24 September 2019

TRACEWAY PARK SOFTBALL CONCESSION STAND
200 Soccer Row
Clinton, MS 39056

ADDENDUM NO. 02

2 DETAIL
1 1/2" = 1'-0"

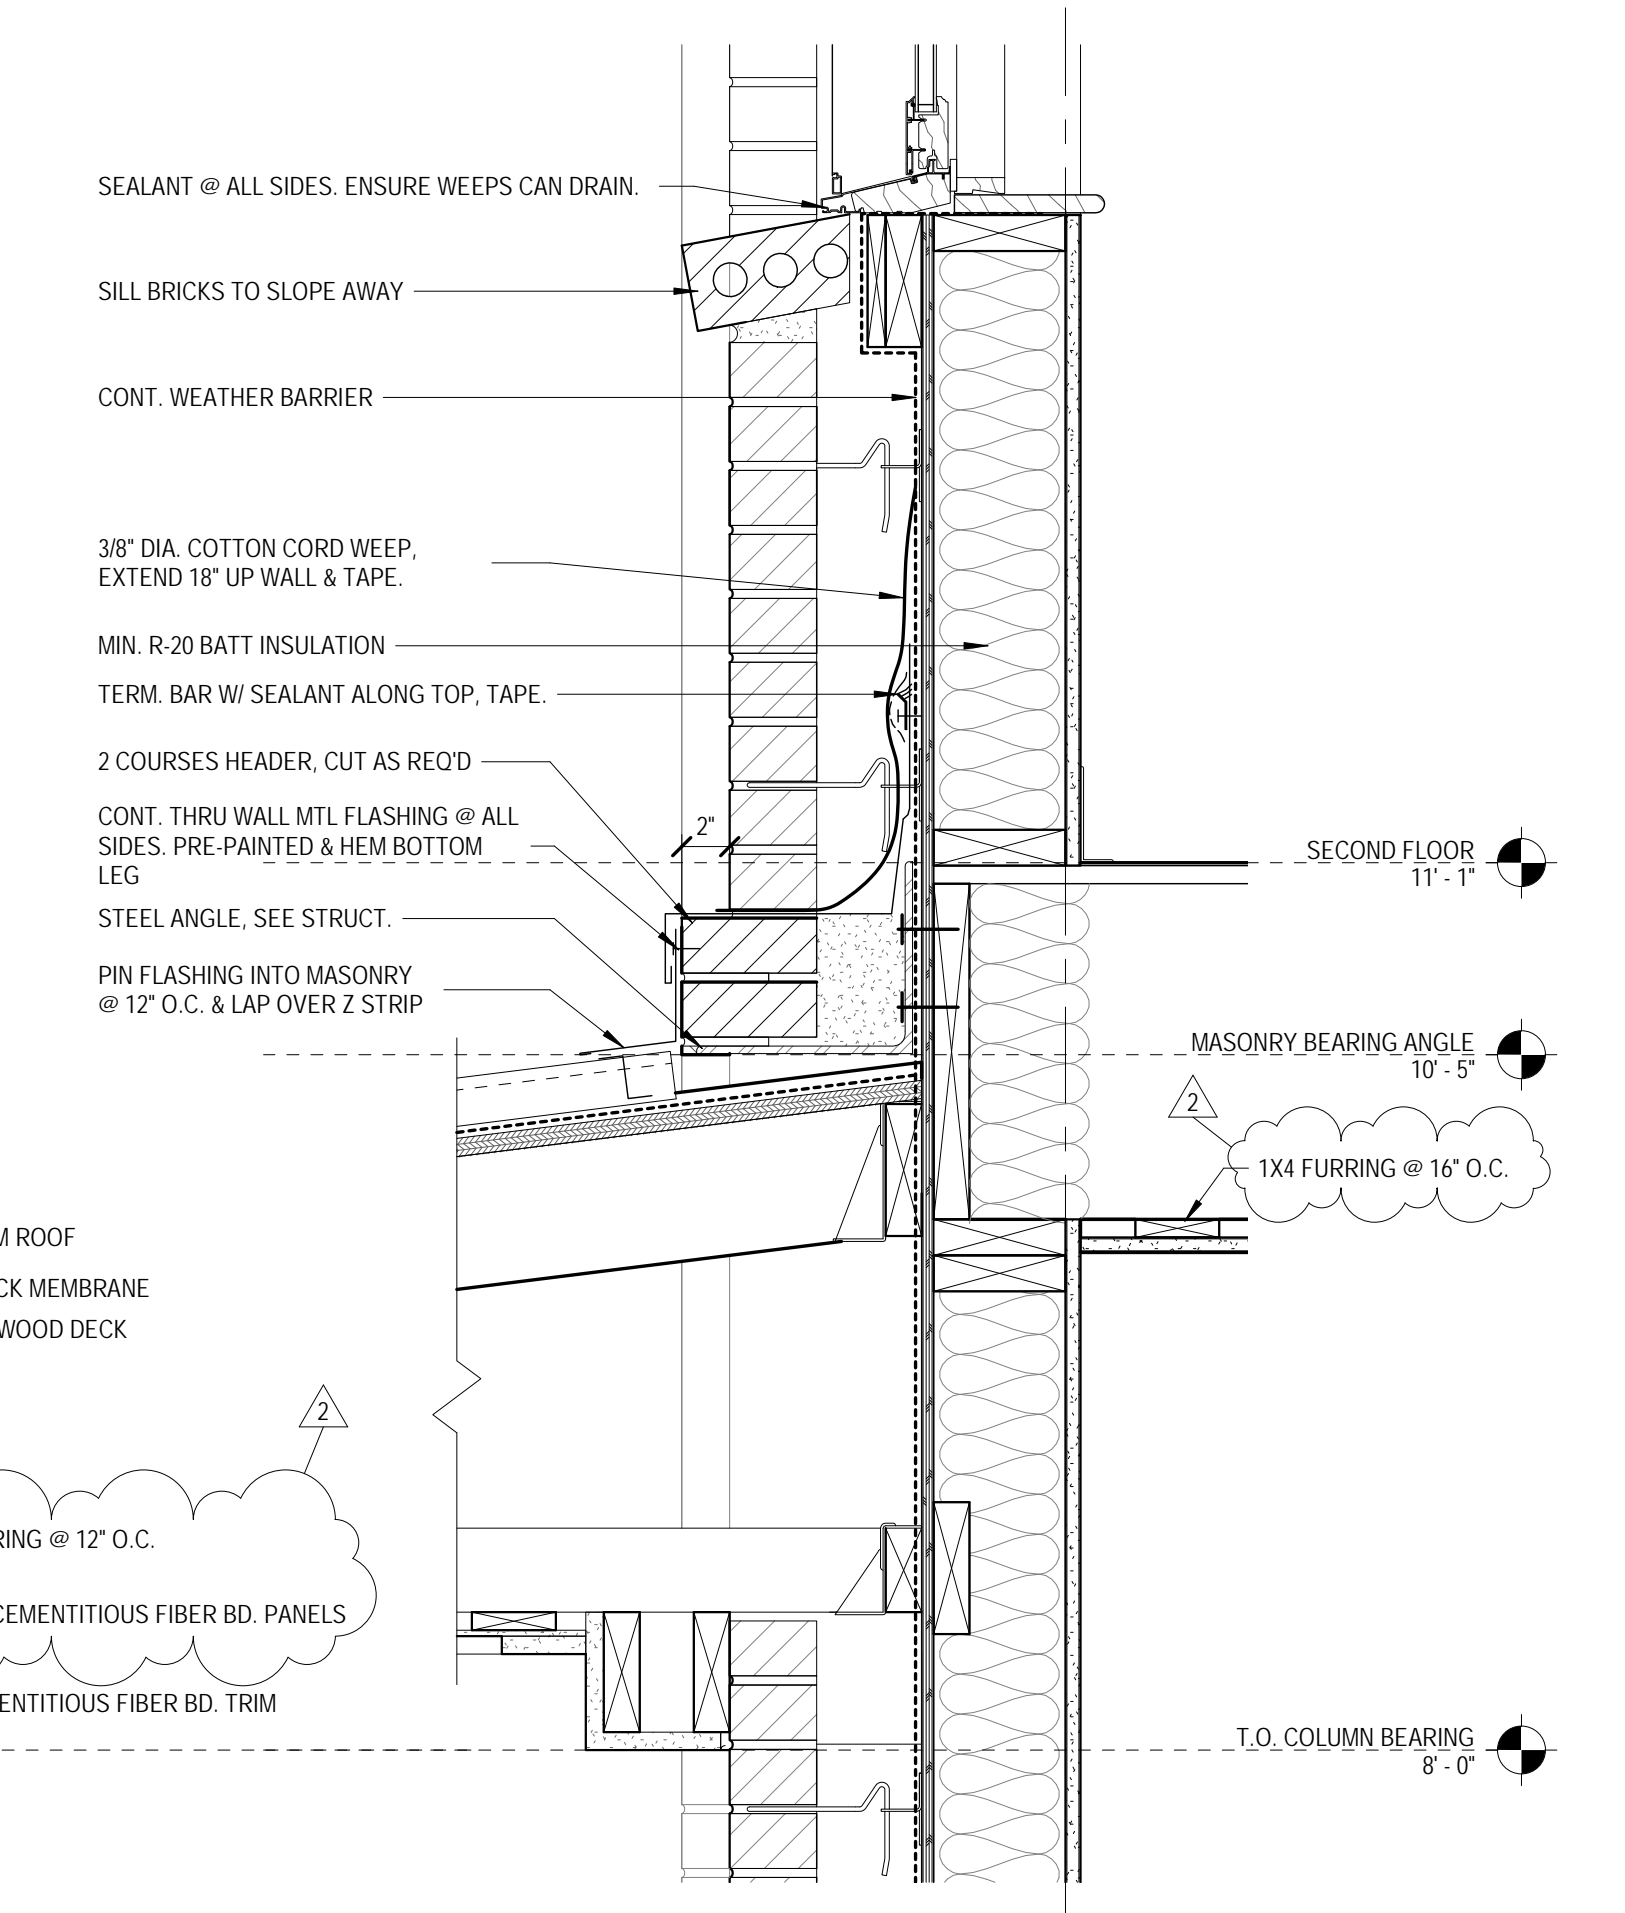
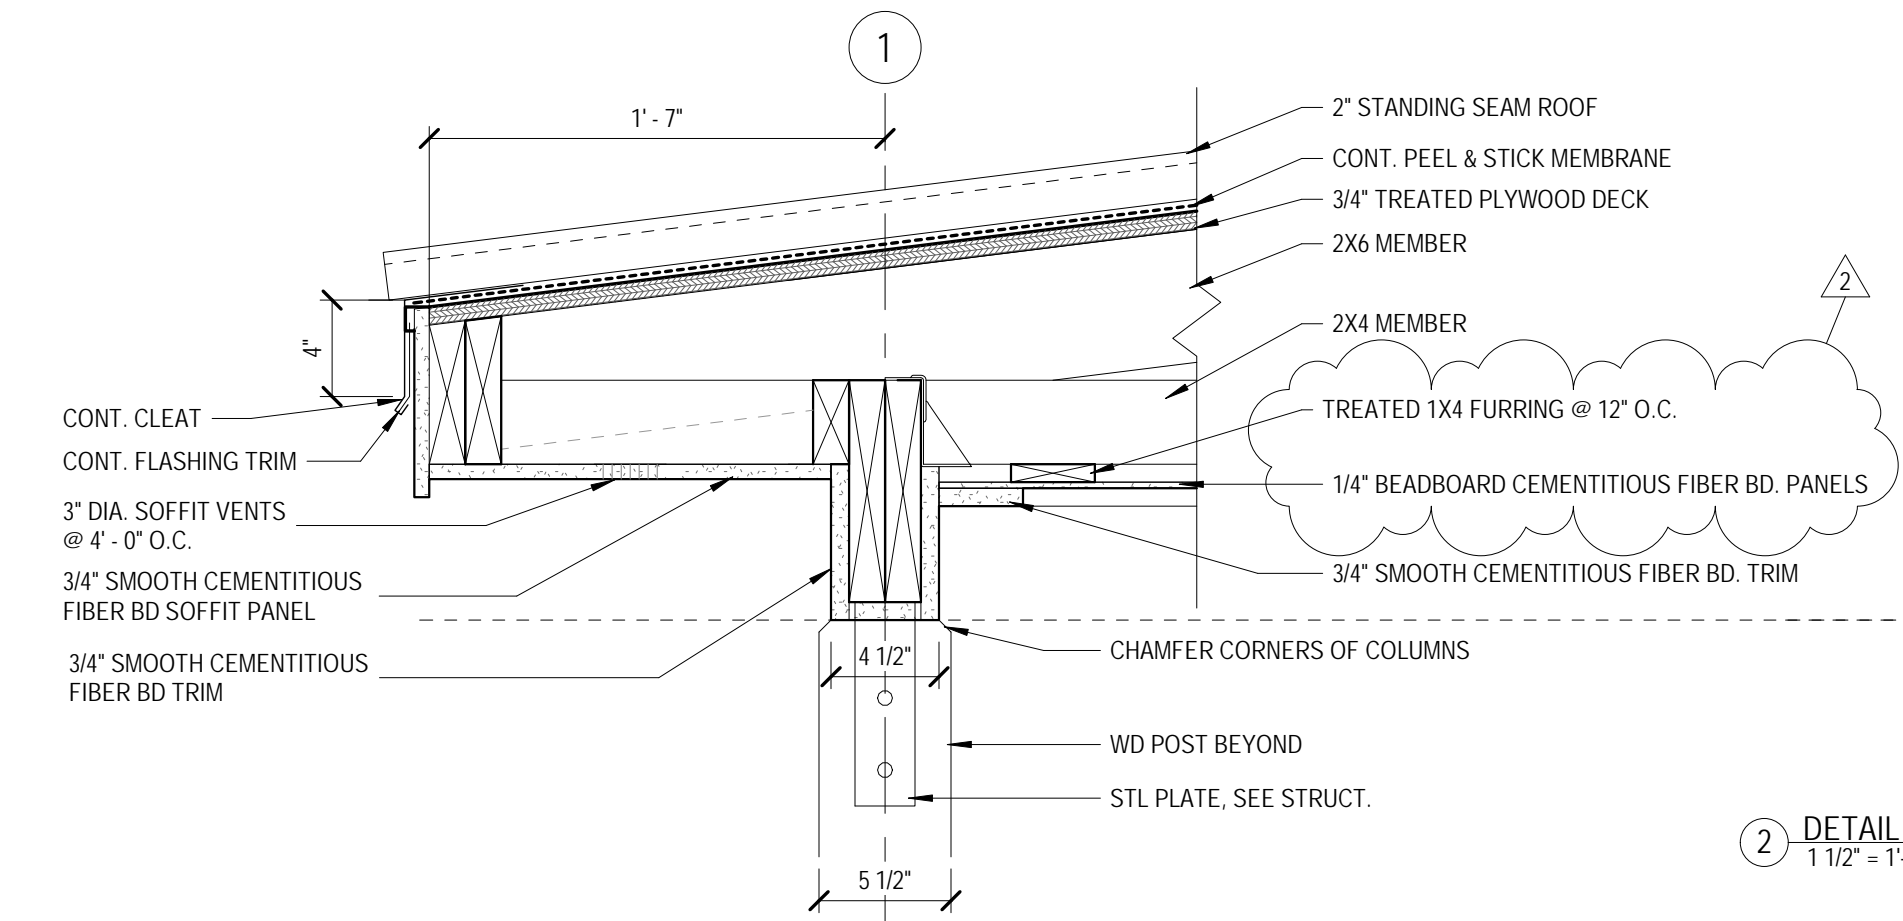
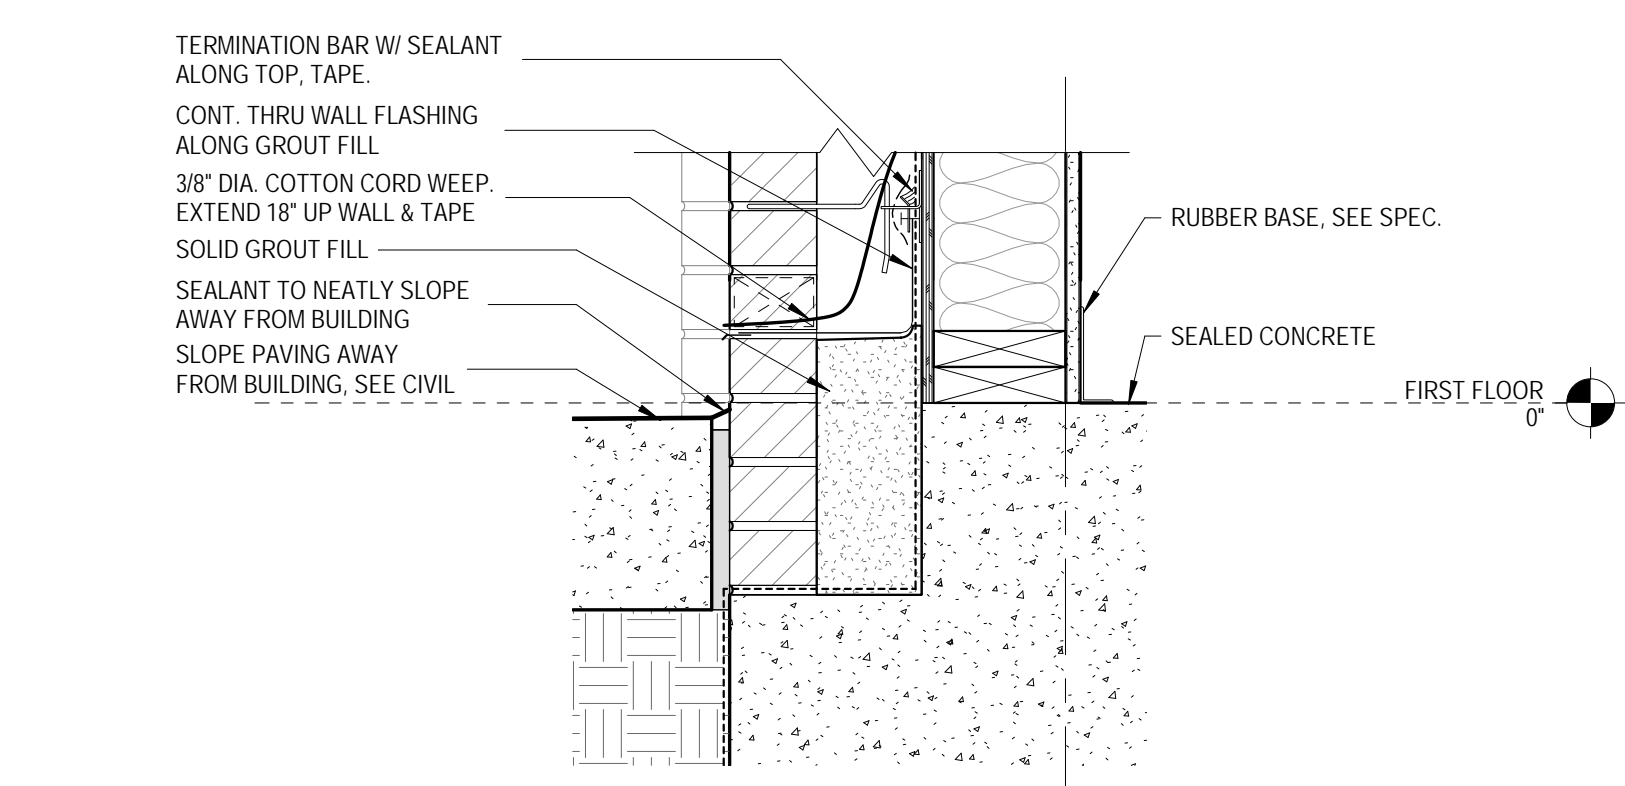
ADD note referencing the overhead coiling shutter doors at each concession window.

ADD note referencing the 1x4 furring boards at 16" on center added to the ceiling structure to support the gyp board at all ceilings.

ADD note referencing treated 1x4 furring boards at 12" on center in the porch area to support the cementitious fiber board soffit panels.

ADD note revising the beadboard cementitious fiber soffit panels in porch area to be ¼" thick.

ADD note referencing the added thermal break cut into the stainless steel counter.
